Site Address: Land at Springfield Rise, Treharris

Development: Article 2D - Proposed residential development forming 23no. affordable dwellings and associated works including sustainable drainage, access, diversion of existing Public Right of Way and completion of existing estate road

PPA0006137 Sewer Plan

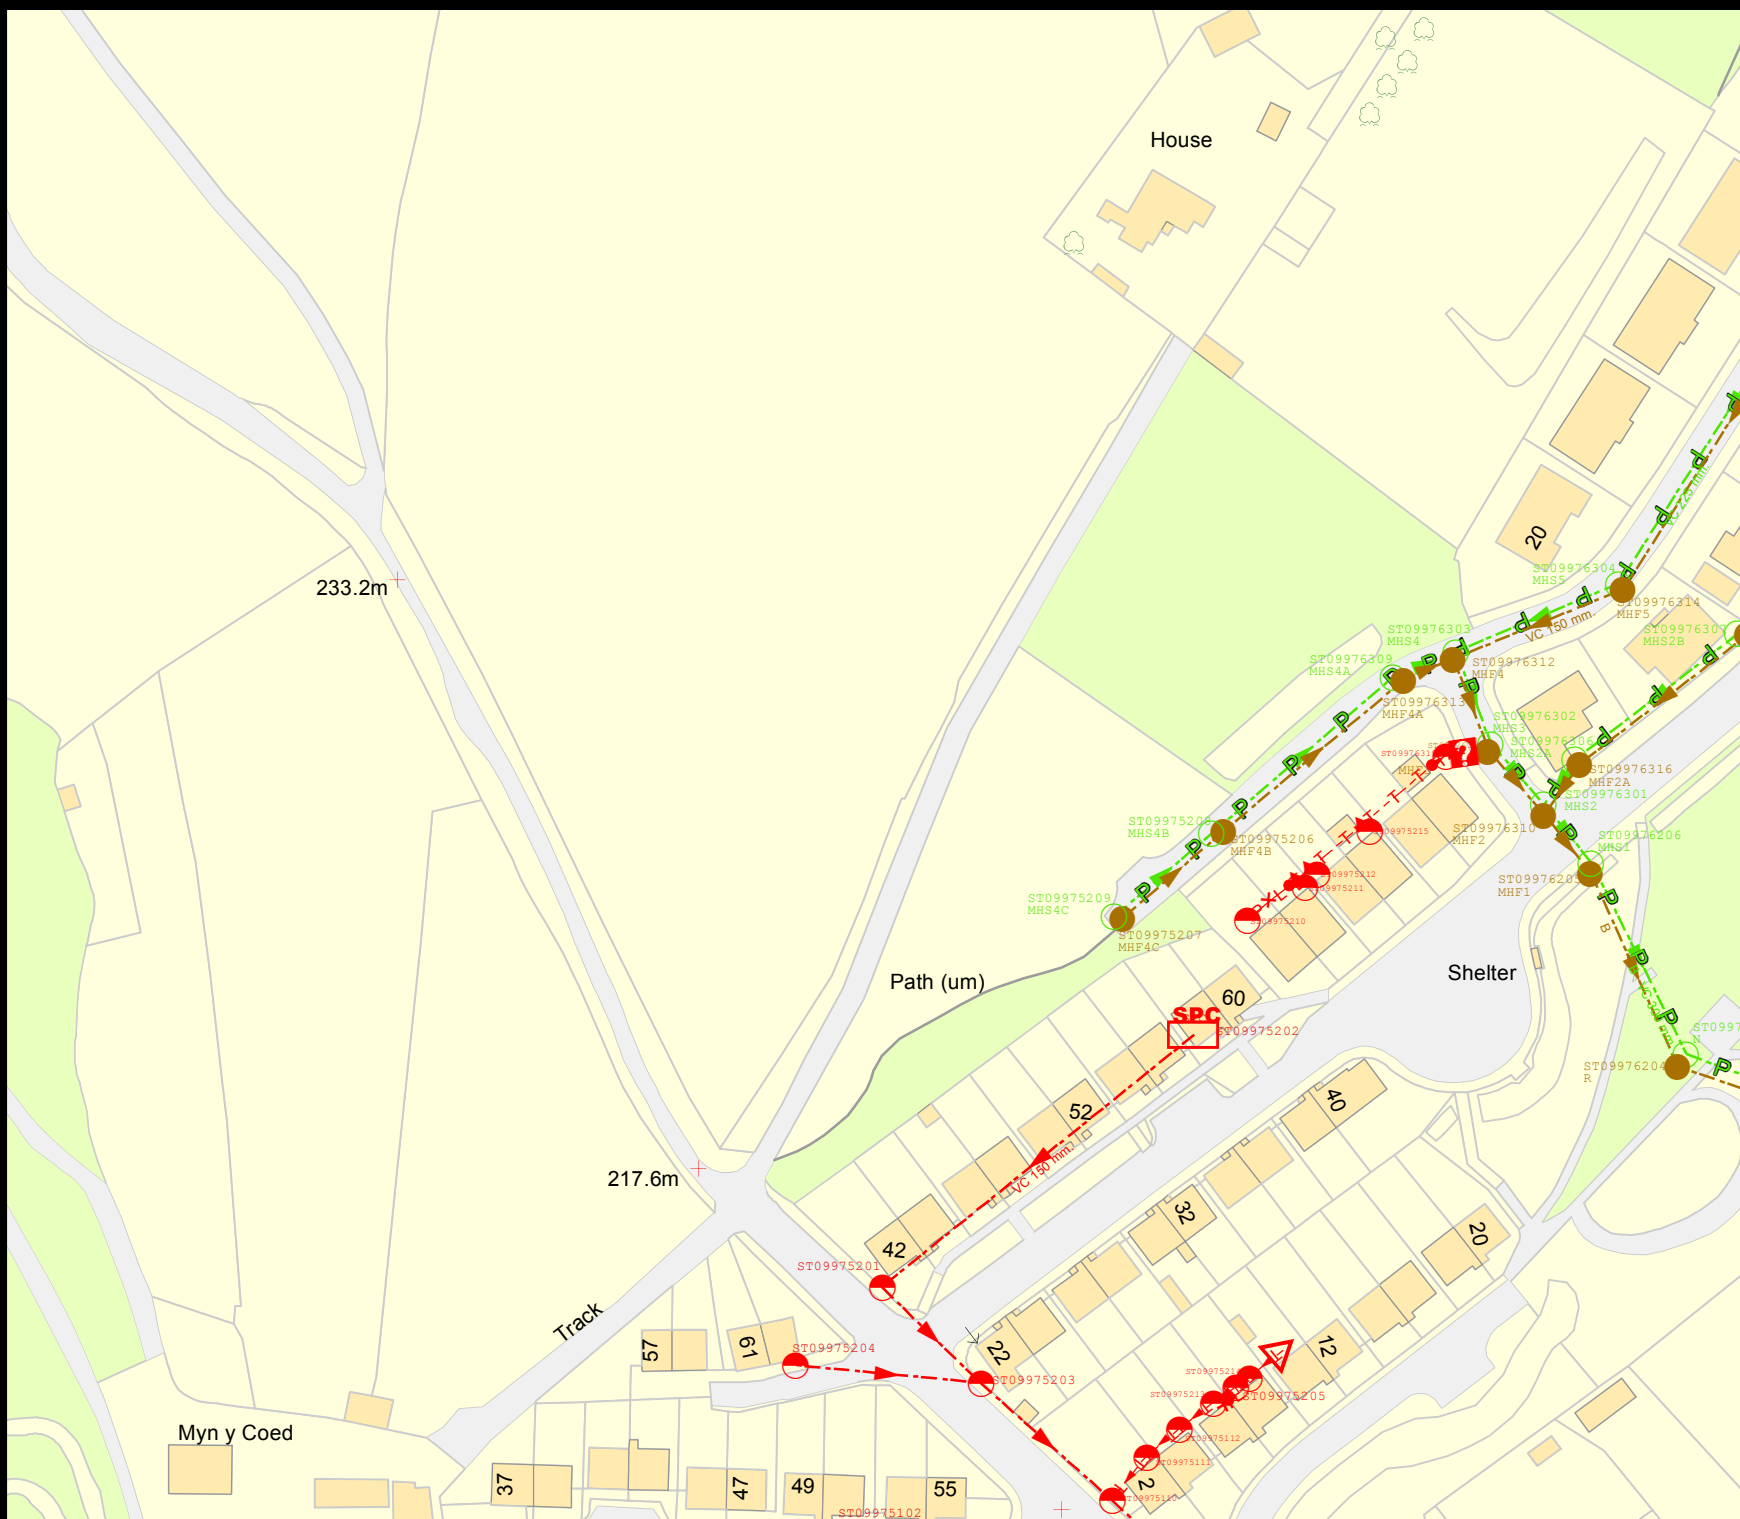
The proposed development site is crossed by both public watermain and a sewer with the approximate position being marked on the attached Statutory Public Watermain and Sewer Record. Under the Water Industry Act 1991 Dwr Cymru Welsh Water has rights of access to its apparatus at all times. I enclose our Conditions for Development near Watermains. It may be possible for this watermain to be diverted under Section 185 of the Water Industry Act 1991, the cost of which will be re-charged to the Developer. Please note that no part of any building or sustainable drainage feature will be permitted within 3 metres either side of the centreline of the public sewer(s).

1. No structure is to be sited within a minimum distance of **3m** from the centre line of the 90mm main and **4.75m** from the centre line of the 225mm main. The pipeline must therefore be located and marked up accurately at an early stage so that the Developer or others understand clearly the limits to which they are confined with respect to the Company's apparatus. Arrangements can be made for Company staff to trace and peg out such water mains on request of the Developer.
